City of Lambertville  
Planning Board  
Regular Meeting Minutes  
Wednesday, May 19, 2021

7 Delevan Street  
Block 1028 Lot 20  
Site Plan and Preliminary Major Subdivision

Reference: Preliminary Major Subdivision & Site Plan Review #2  
7 Delevan Street Townhouse Subdivision  
7 Delevan Street (Block 1028, Lot 20)  
City of Lambertville, Hunterdon County, New Jersey

## Planning Report #3

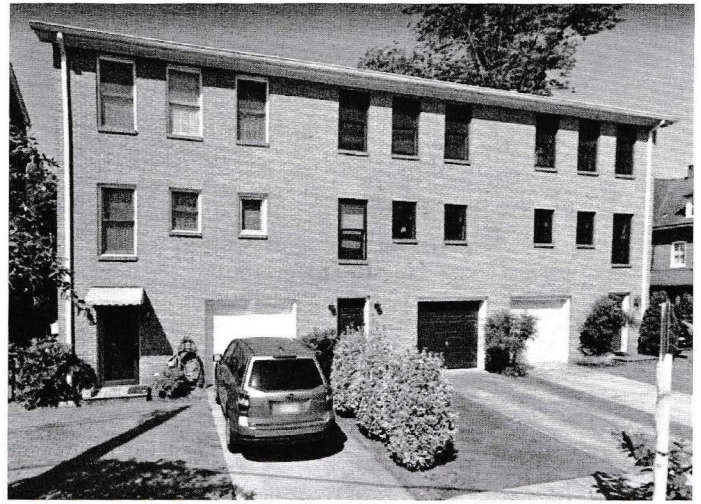
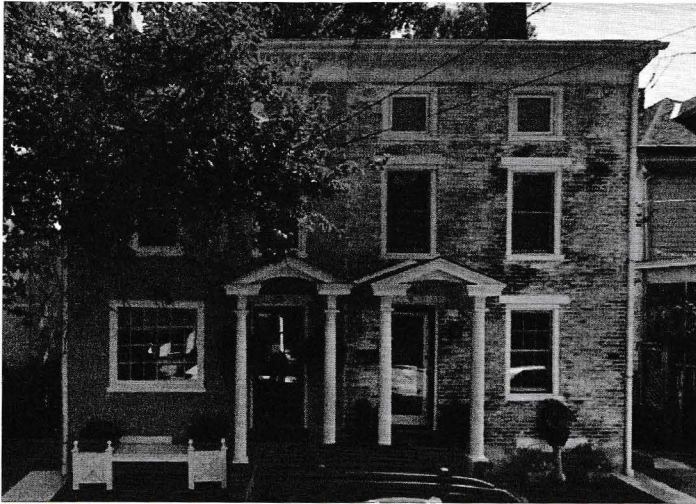
- a. Per Lambertville Design Guidelines §5.1.1.h, "Buildings on corner lots have frontages on two public streets. Both façades should be designed as the front of a building, although only one front door is necessary." The pattern and proportionality of the windows on the Clinton Street facade appear more as a "side facade" than a "street facade". We recommend greater attention be given to this facade, and at a minimum provide a typical pattern, orientation, size, and trim of windows and doors.

- b. Larger and more traditionally proportioned windows should be provided on all facades. Muttons/mullions should be provided in the windows, as is provided on many surrounding single and multi-family properties such as the adjacent property pictured left but not shown on the picture to the right.

*The revised architecture now makes the Clinton Street façade appear more like a front façade with larger windows with improved trim and pattern, as well as a more distinct entrance to this side of the building.*

*The revised architecture now shows larger windows on all upper floors and includes muttons/mullions which is an improved design. However, this revised design has smaller ground floor windows on the Delevan Street facade. We recommend window sizes be increased to fill the negative space and that additional features be added between or under the windows – such as window boxes, wall trellis systems, and/or shutters.*

*Ground floor windows have been enlarged with trim detail and shutters added on the Delevan Street façade.*
